Well Name: GALLEGOS FEDERAL 26-12-6	Well Location: T26N / R12W / SEC 6 / SESW / 36.51231 / -108.15599	County or Parish/State: SAN JUAN / NM
Well Number: 2	Type of Well: OTHER	Allottee or Tribe Name:
Lease Number: NMSF080238A	Unit or CA Name:	Unit or CA Number:
US Well Number: 3004528898	Well Status: Gas Well Shut In	Operator: HILCORP ENERGY COMPANY

Notice of Intent

Type of Submission: Notice of Intent	Type of Action: Plug and Abandonment
Date Sundry Submitted: 06/09/2022	Time Sundry Submitted: 12:48
Date proposed operation will begin: 06/30/2022

Well: Gallegos Federal 26-12-6 2

Wellbore Schematic - PROPOSED

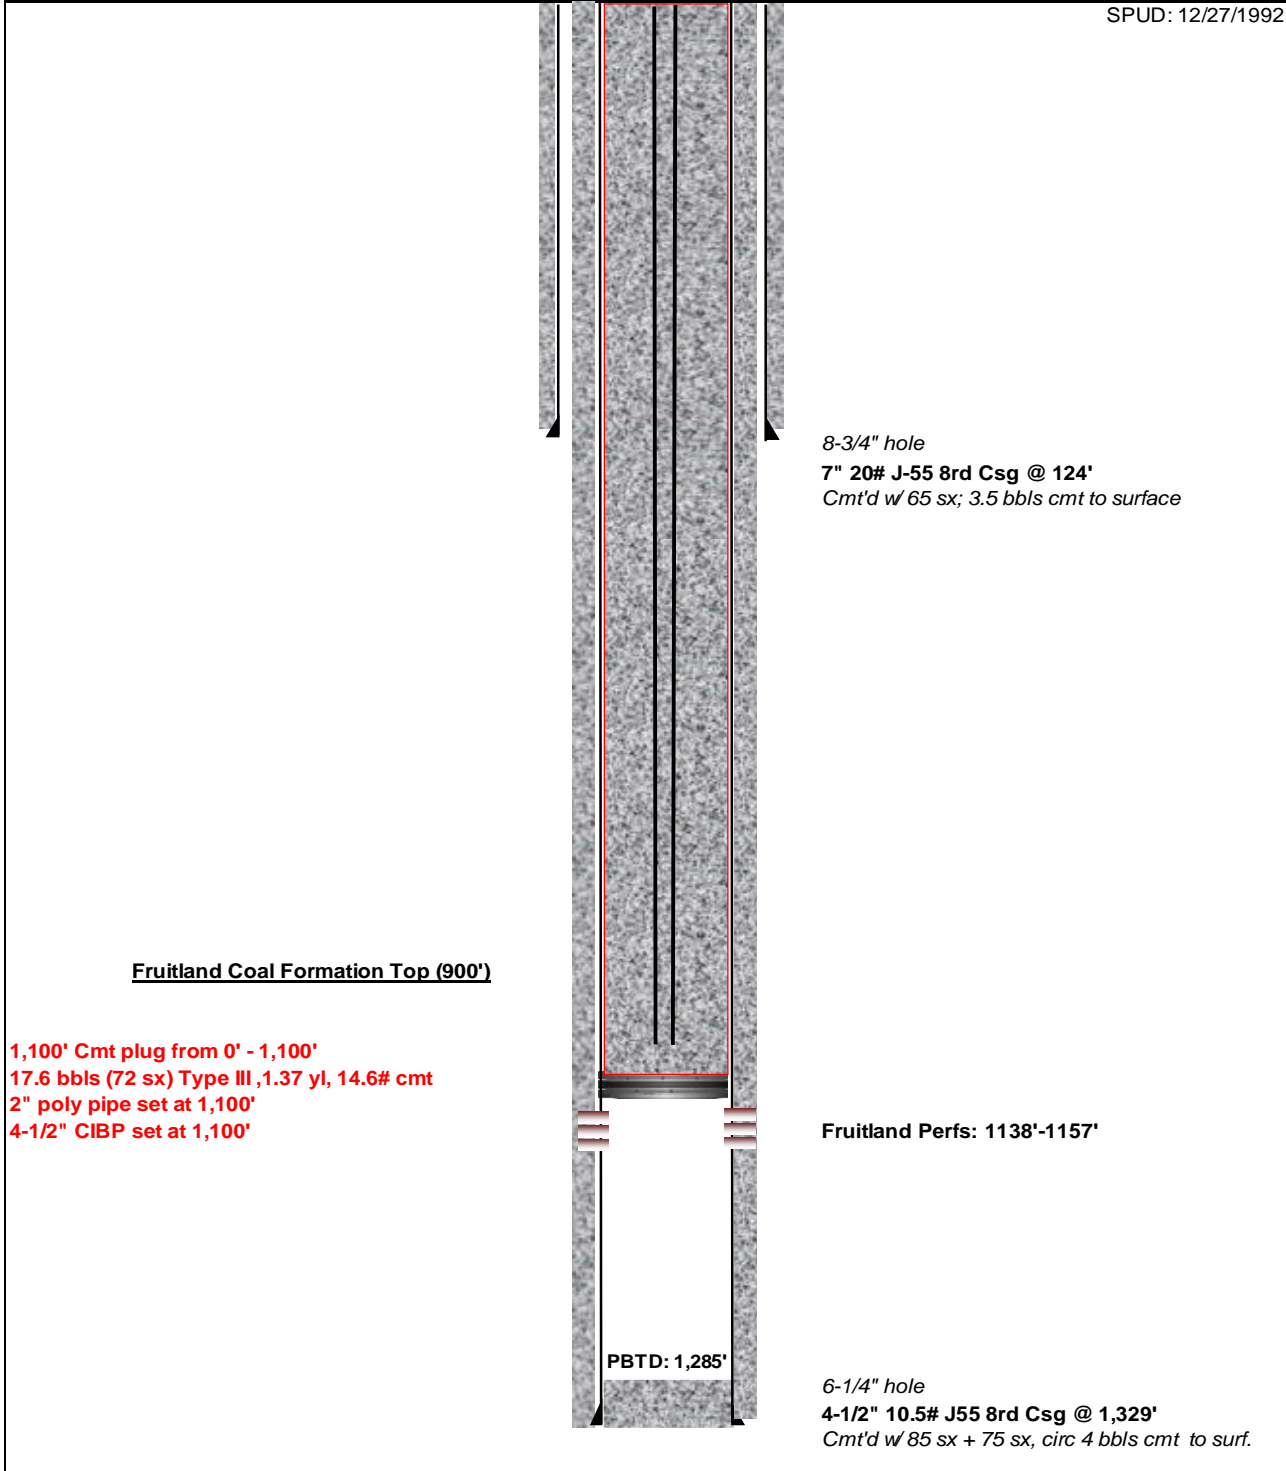
You are also required to place cement excesses per 4.2 and 4.4 of the attached General Requirements.
